EXHIBIT 4

COMPILED PUNCH LIST
DENTON AIRPORT HANGARS
May 26, 2016

Hangar Facilities #2241, 2231, 2221, 2031, 2041 2051 , 2061
Denton Municipal Airport
Denton, TX

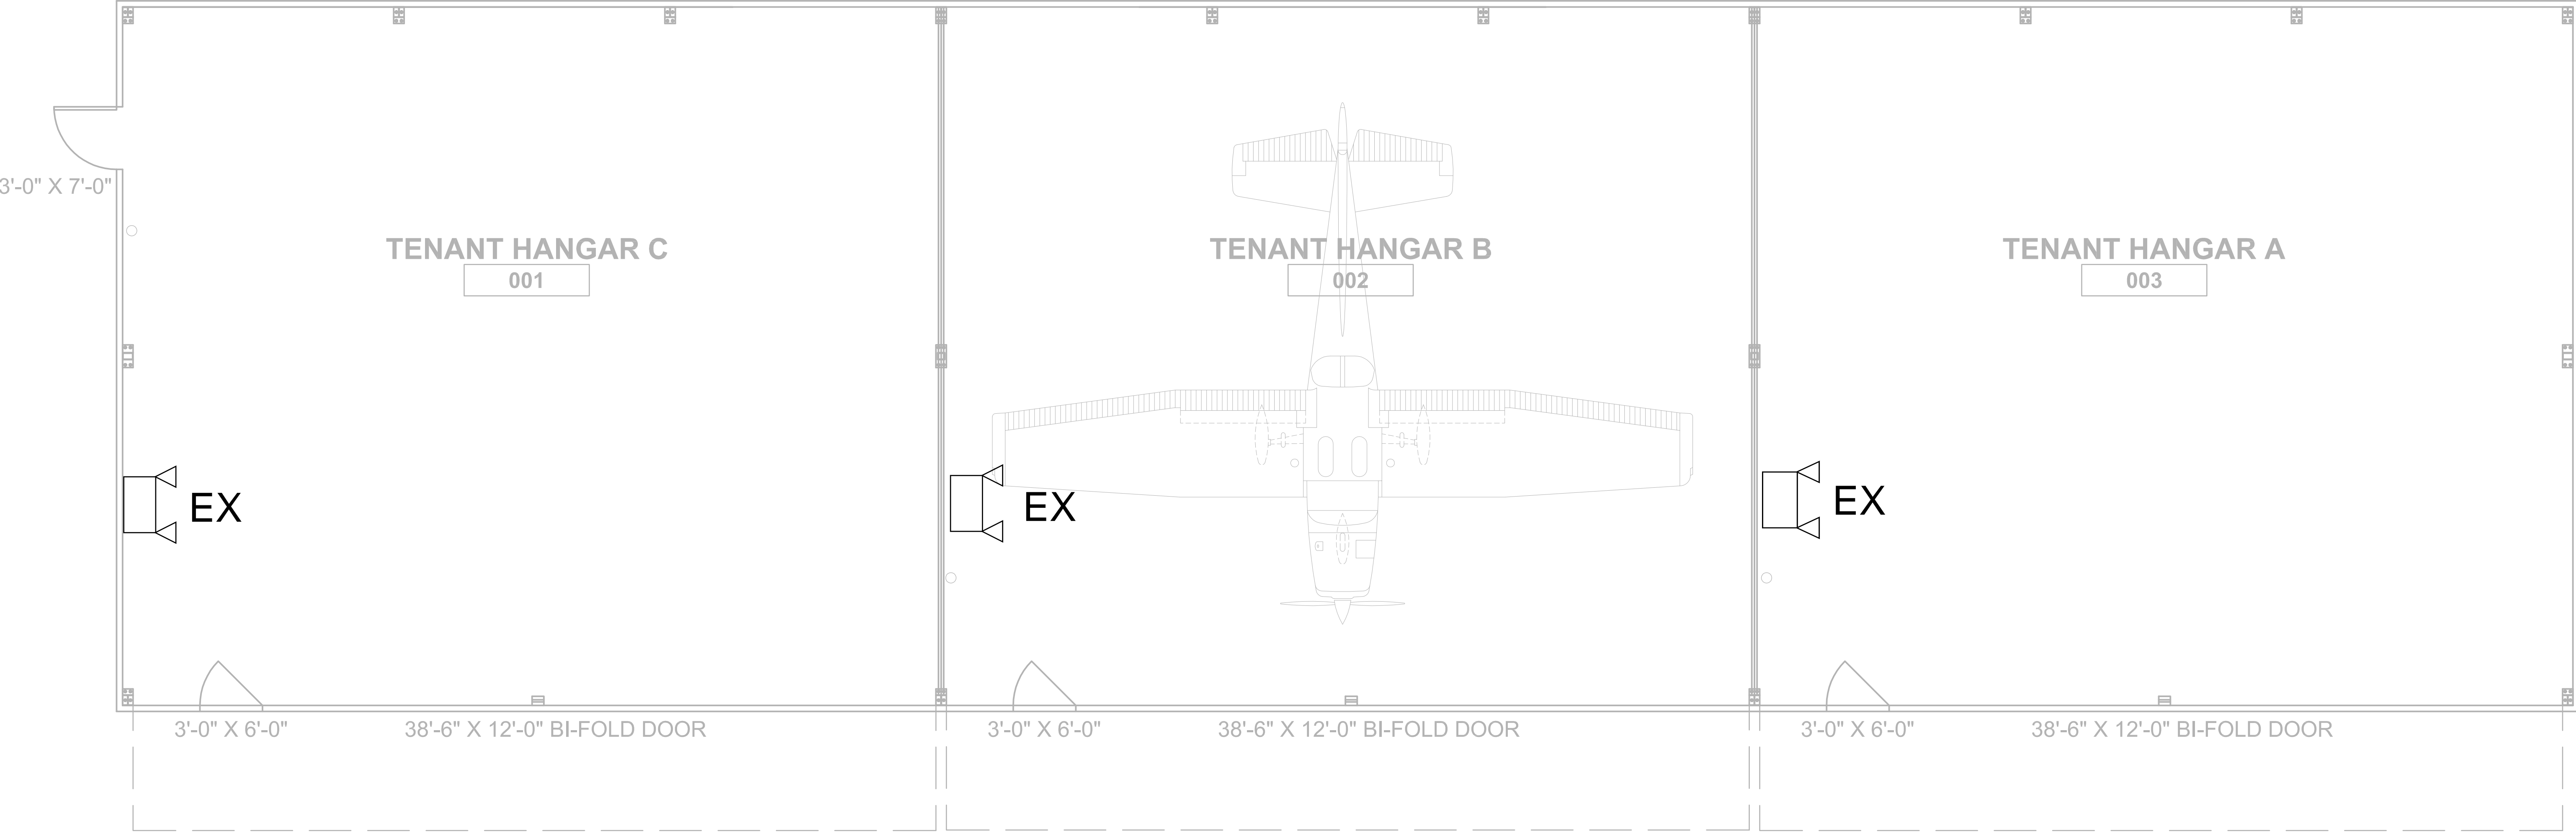
EMERGENCY LIGHT LEVEL MEASUREMENTS WERE TAKEN AND IT HAS BEEN DETERMINED THAT IT WOULD BE POSSIBLE TO OBTAIN THE MINIMUM LIGHT LEVEL REQUIREMENTS FOR EGRESS LIGHTING BY ADJUSTING THE (2) HEADS ON THE EMERG. FIXTURE SO THAT THEY PROVIDE ILLUMINATION ALONG PATH OF EGRESS. CONTRACTOR TO ADJUST HEADS AS REQUIRED.

ARI RECOMMENDS PROVIDING ADDITIONAL
EMERGENCY LIGHTS AS INDICATED BELOW.
CONTRACTOR TO VERIFY EXACT QUANTITY,
LOCATION, AND HEAD ADJUSTMENTS TO MEET
REQUIRED Fc LEVELS ALONG PATH OF EGRESS.
